42 HONEYSUCKLE DRIVE COTTAGE CREEK PRECINCT NEWCASTLE

NEWCASTLE CITY COUNCIL
DEVELOPMENT APPLICATION

ARCHITECTURAL DESIGN STATEMENT

SUMMARY OF PROPOSED AMENDMENTS

4.1

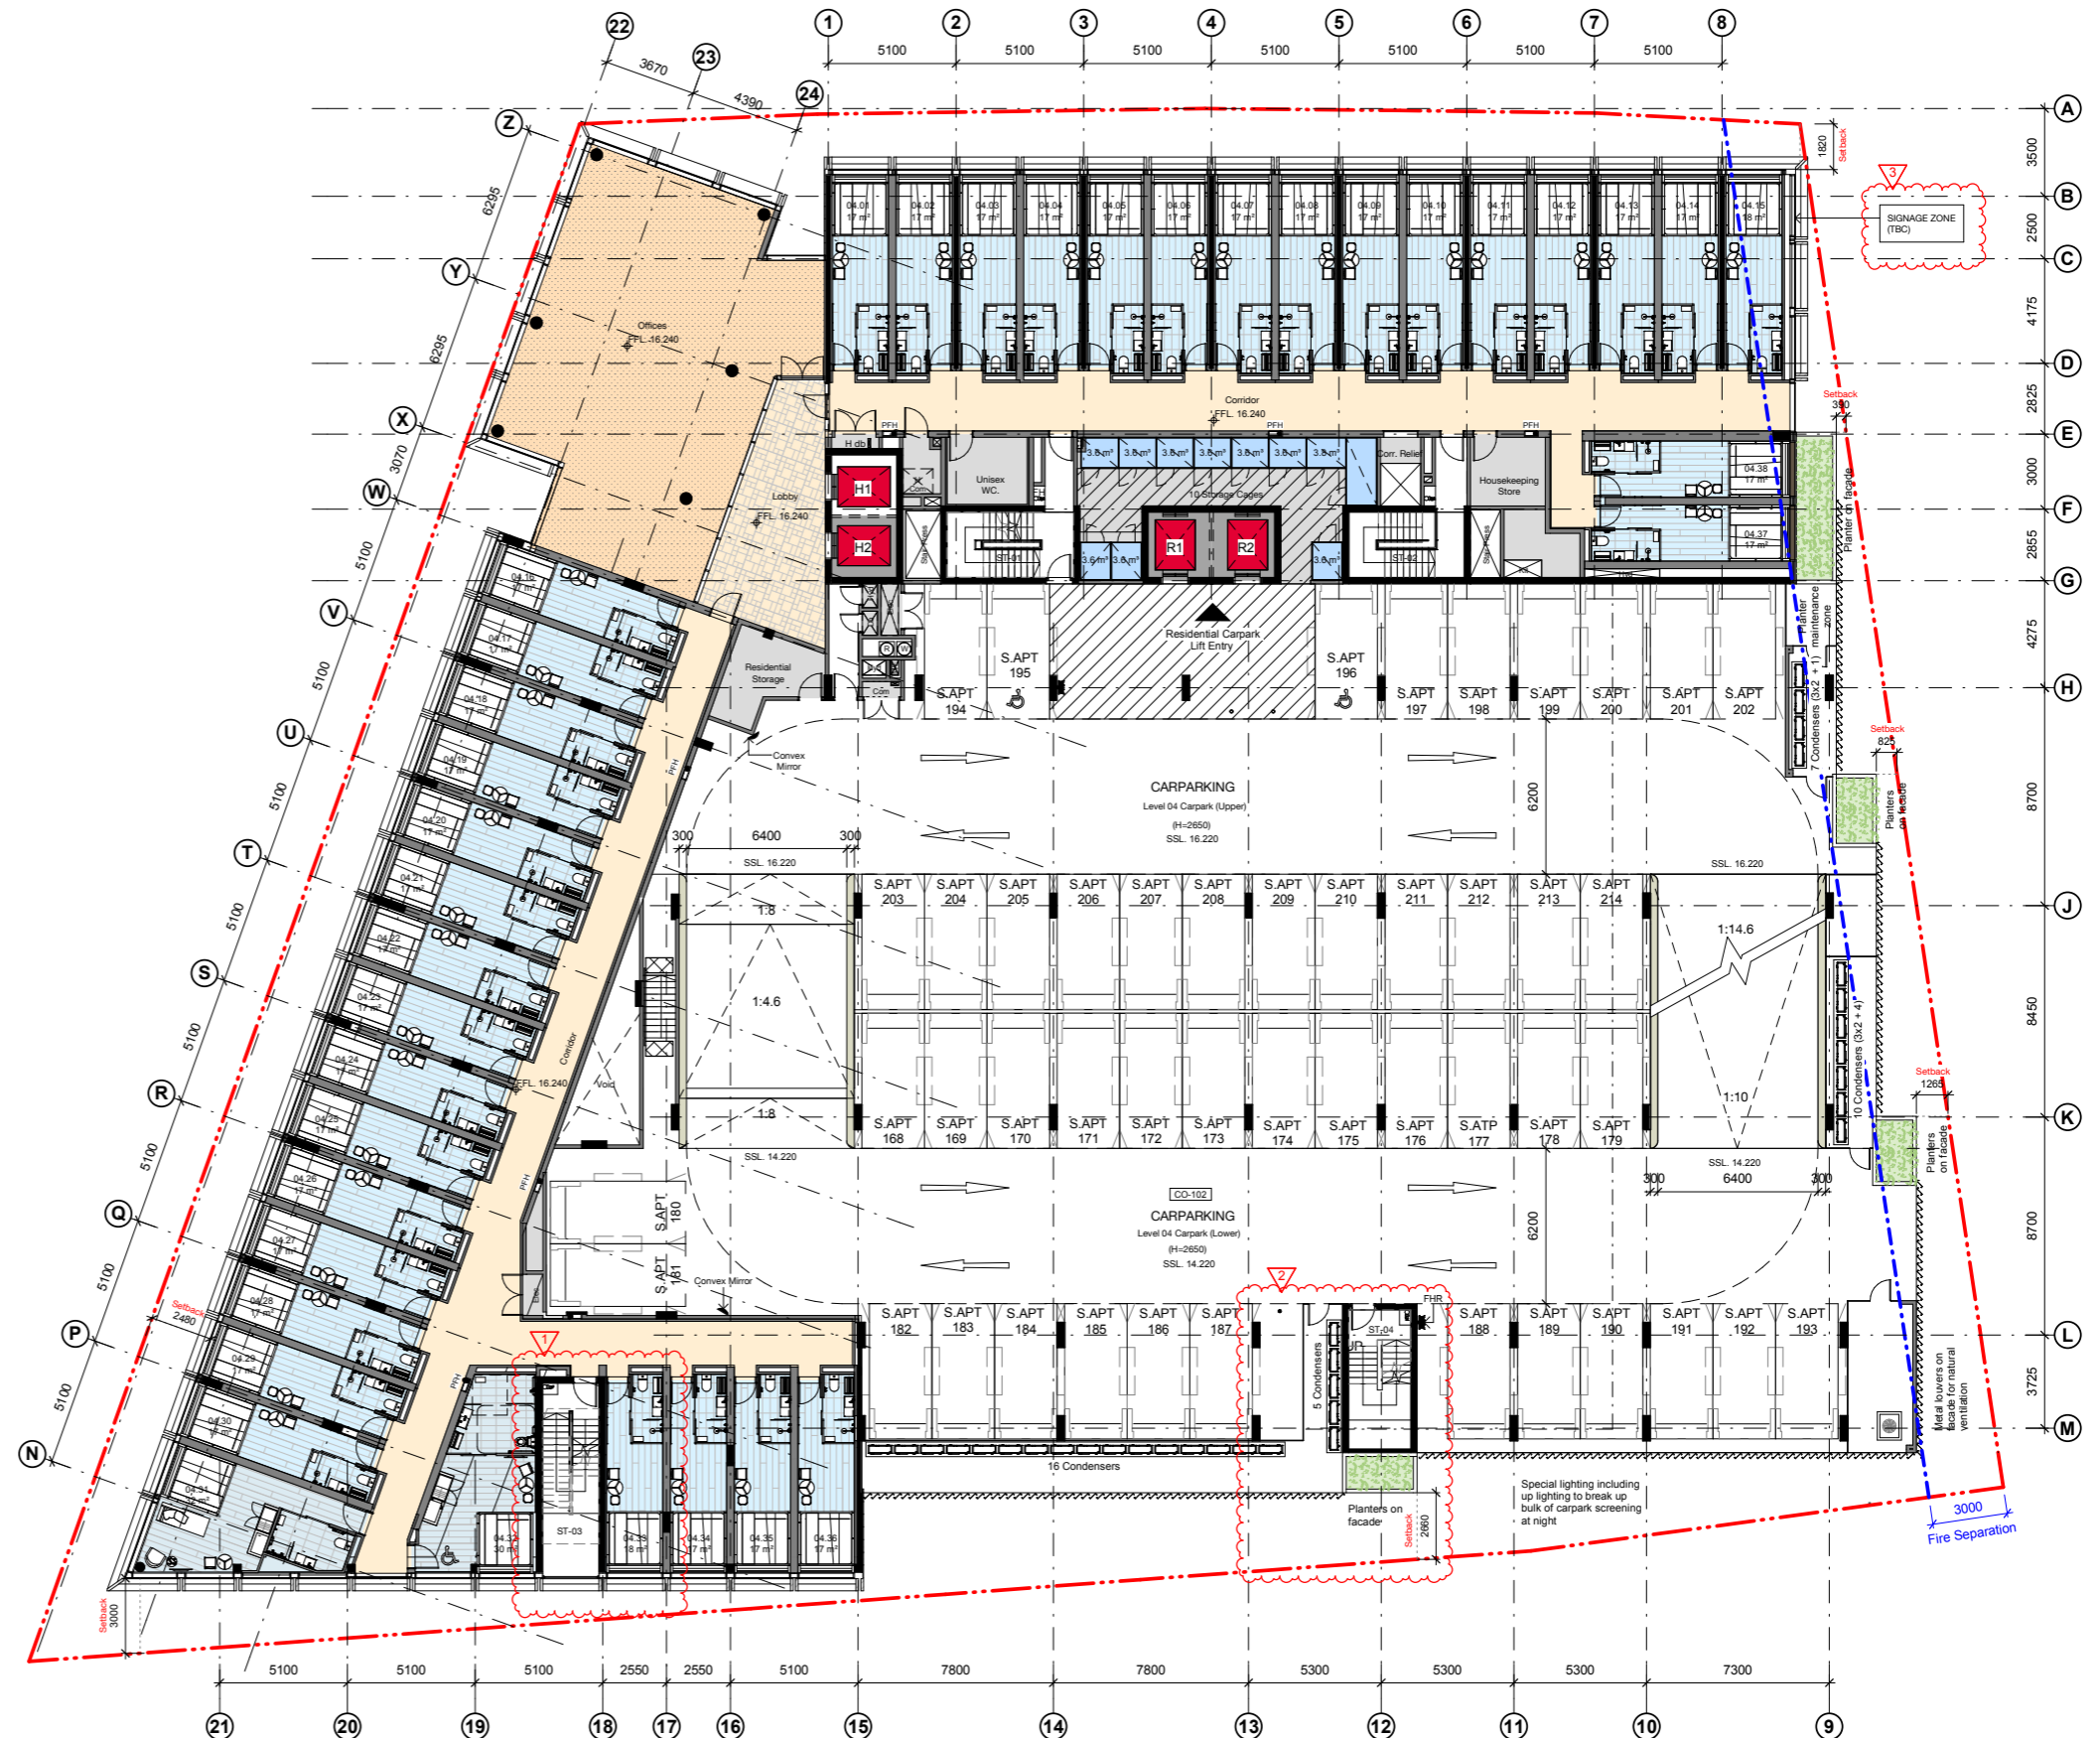
1 / Adjustments to the location of the south western fire stair. To accommodate the revised serviced apartment floorplate, the fire stair shifts to the west by one hotel bay. Facade treatment from Ground to Level 04 are adjusted to suit.

2 / Adjustments to the location of the south eastern fire stair. To accommodate the revised serviced apartment floorplate, the fire stair shifts to the east. Facade treatment from Ground to Level 05 Parking are adjusted to suit.

3 / Addition of signage zones to the external building facade.

5.1 DESIGN CHANGES FIFTH FLOOR PARKING

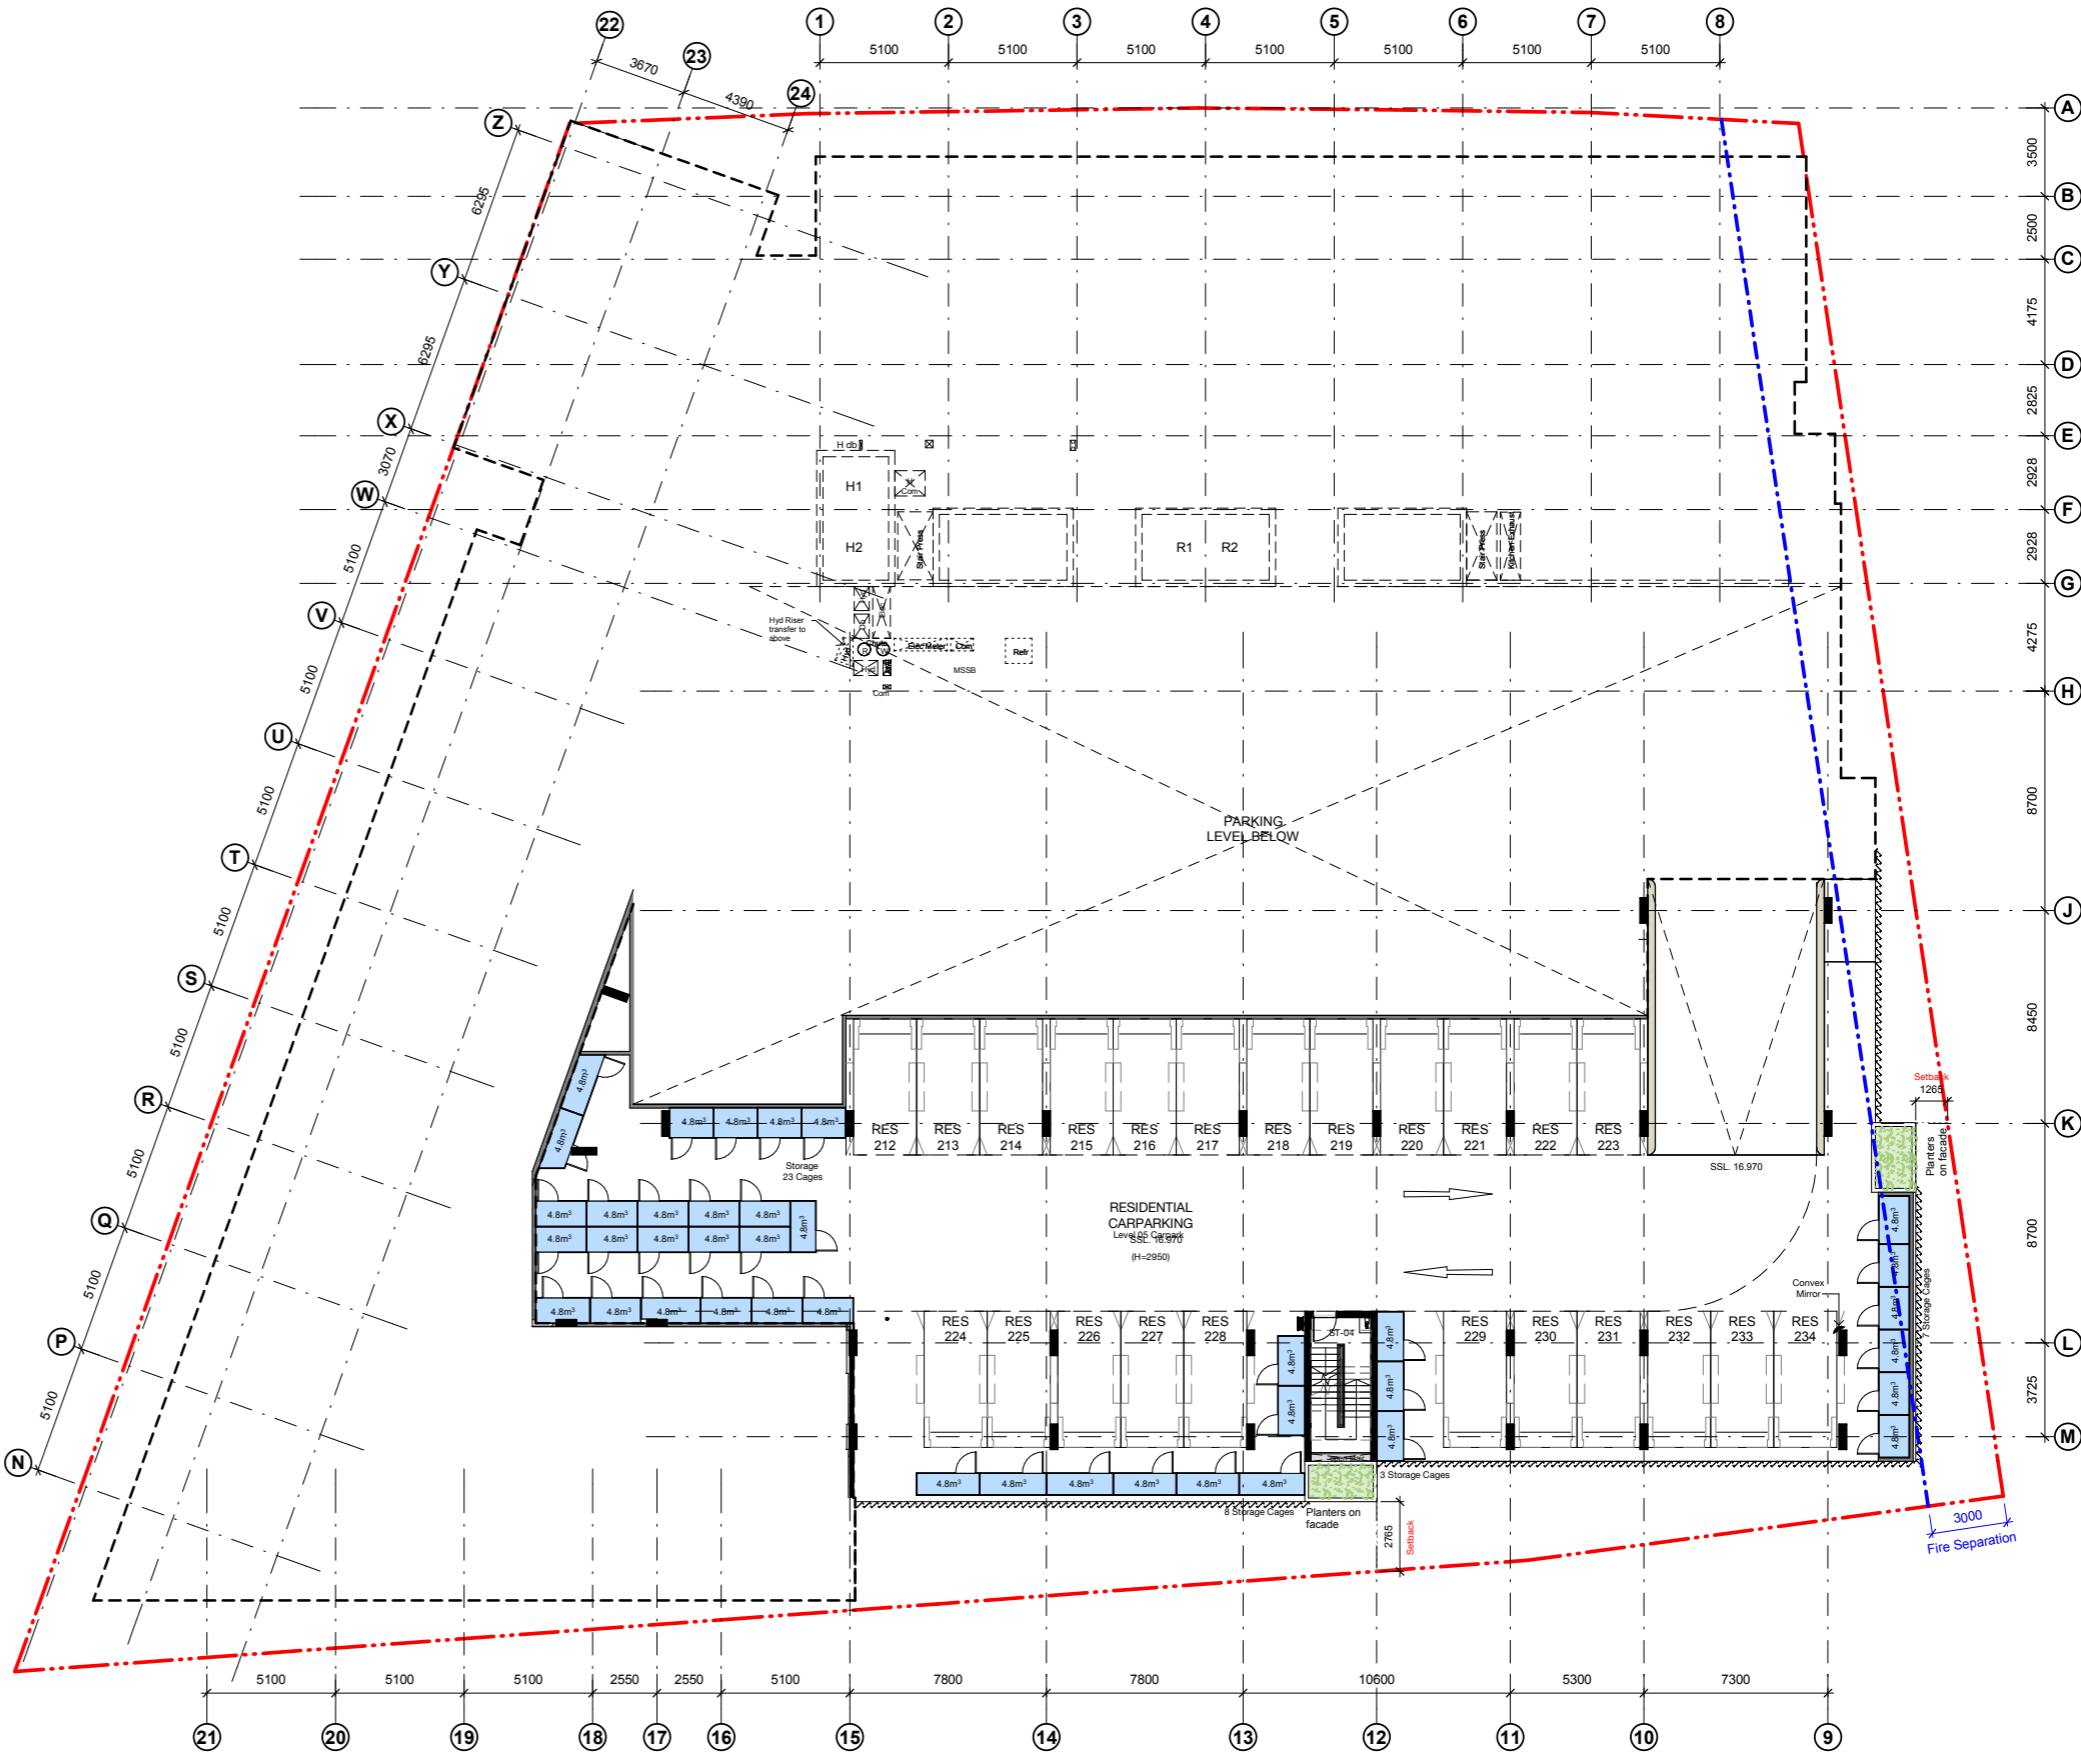
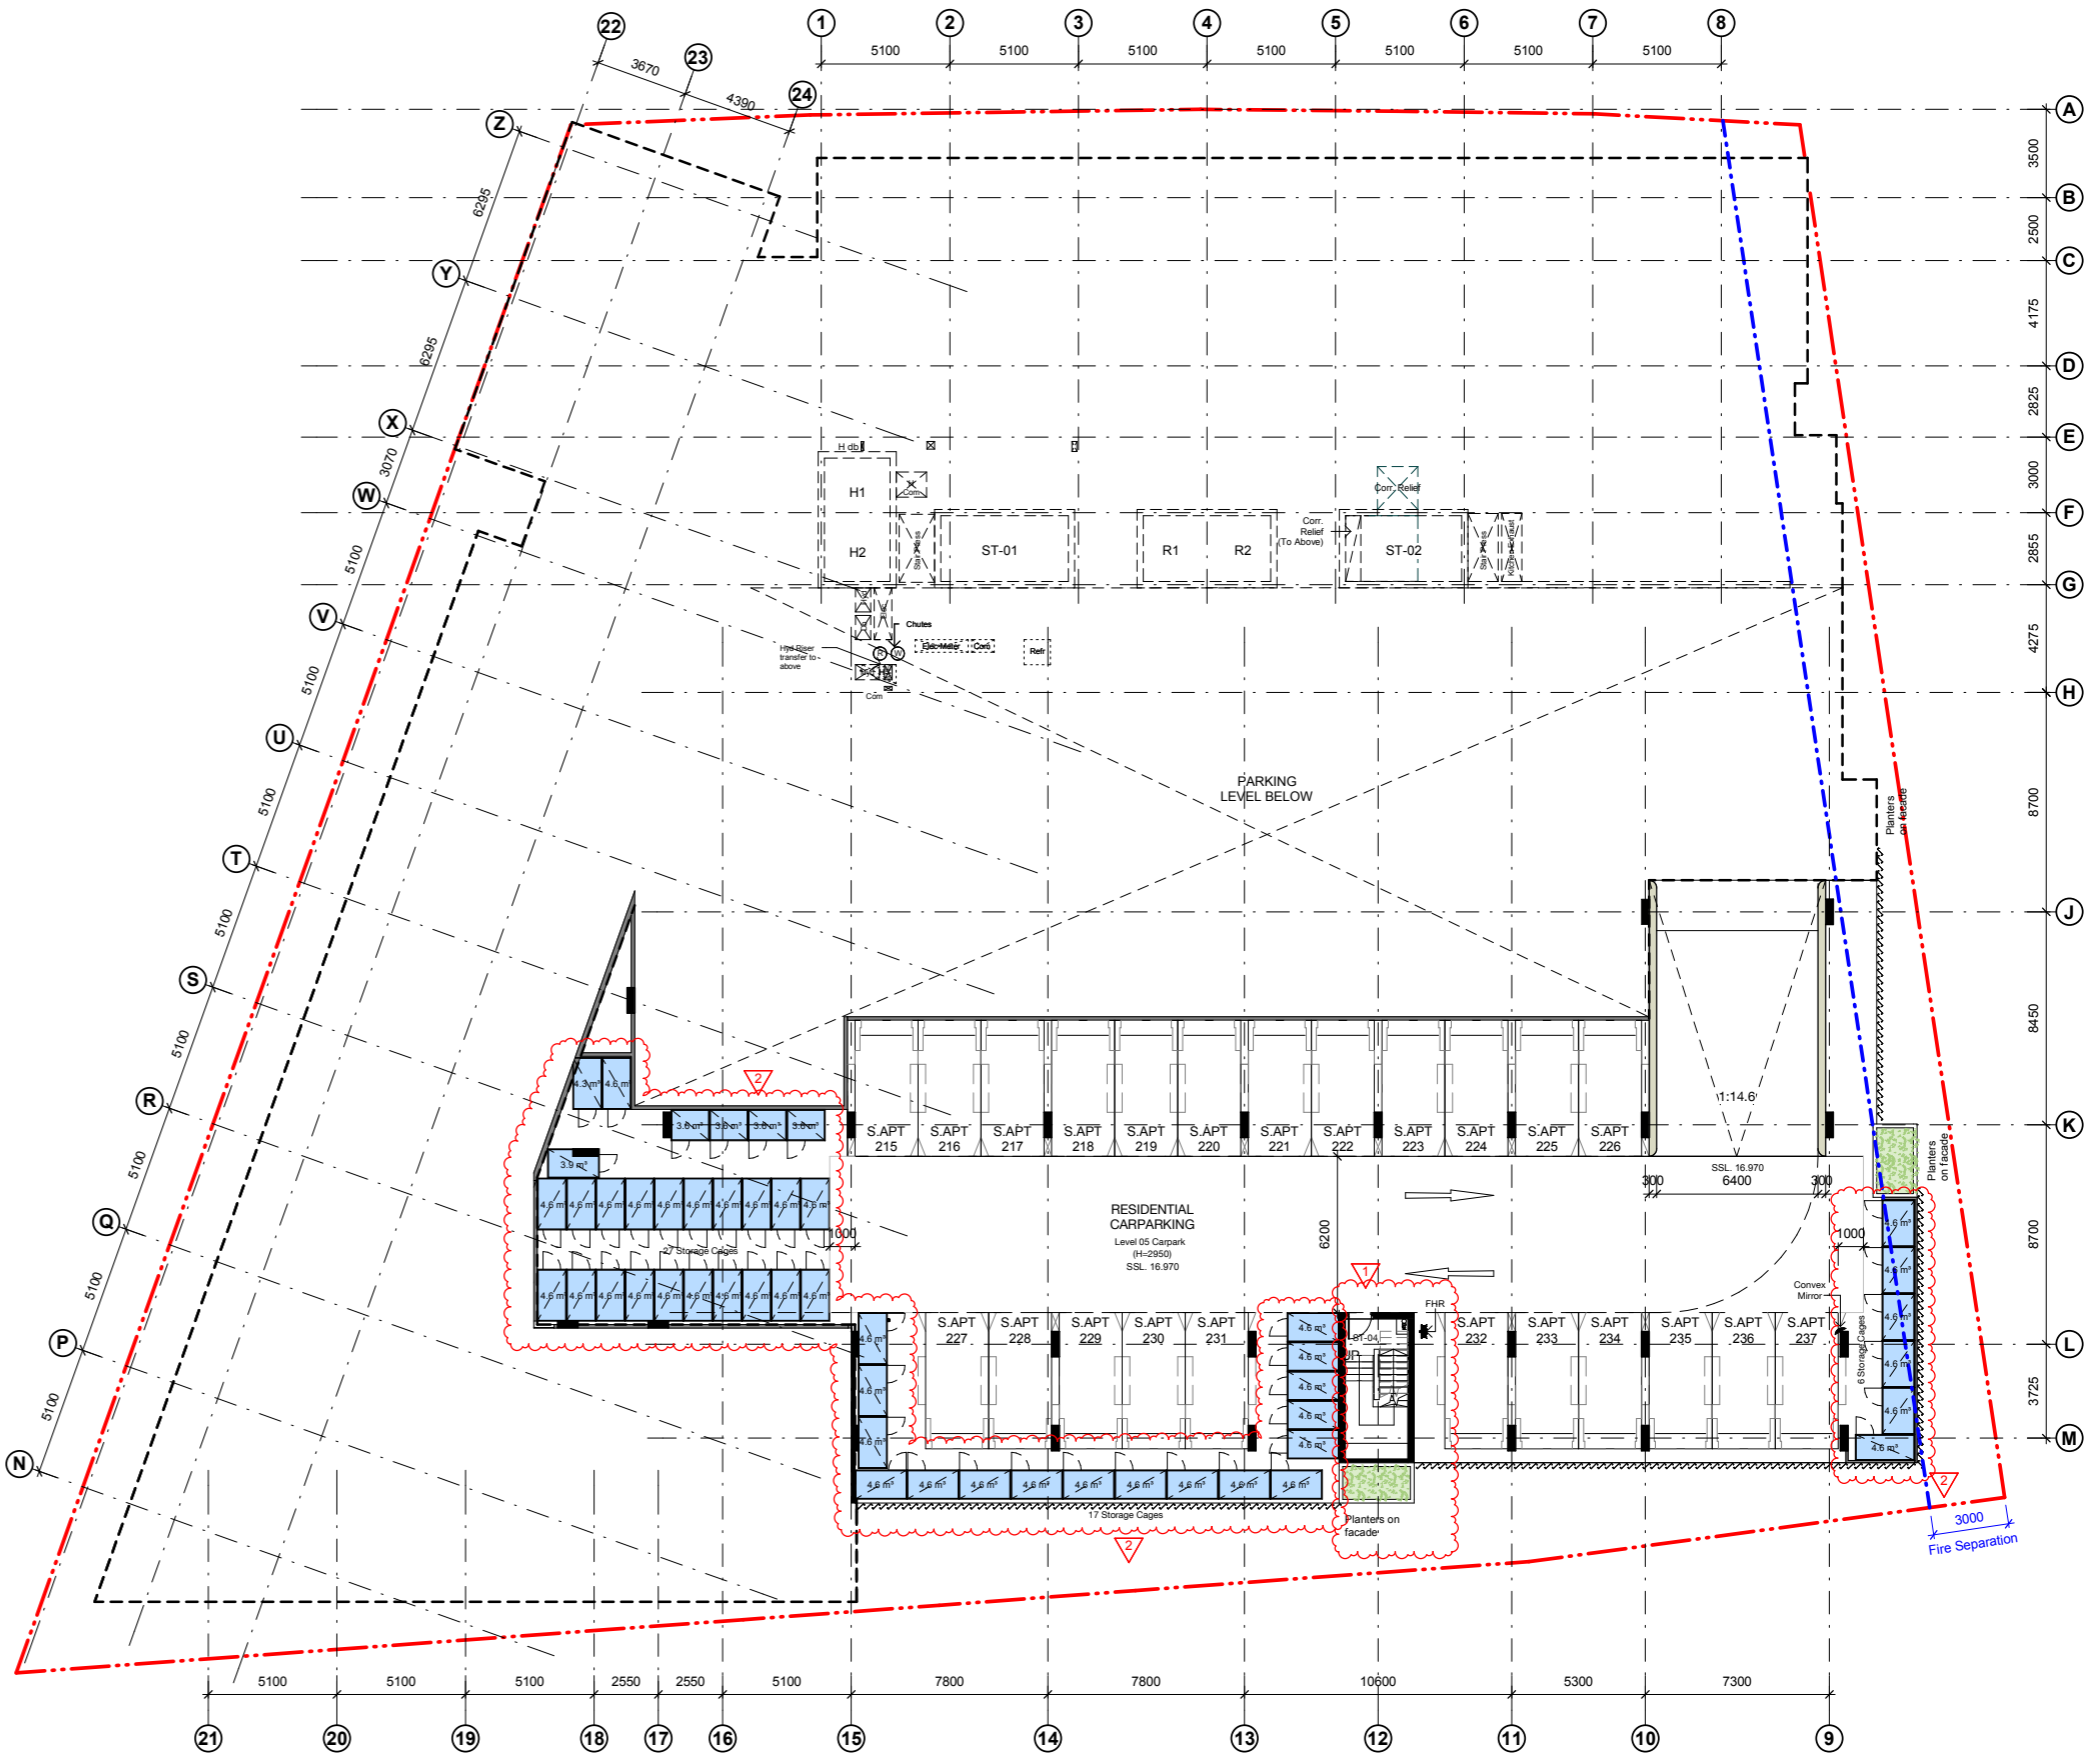
- 1 / Adjustments to the location of the south eastern fire stair. To accommodate the revised serviced apartment floorplate, the fire stair shifts to the east. Facade treatment from Ground to Level 05 Parking are adjusted to suit.
- 2 / Storage cage arrangements updated.
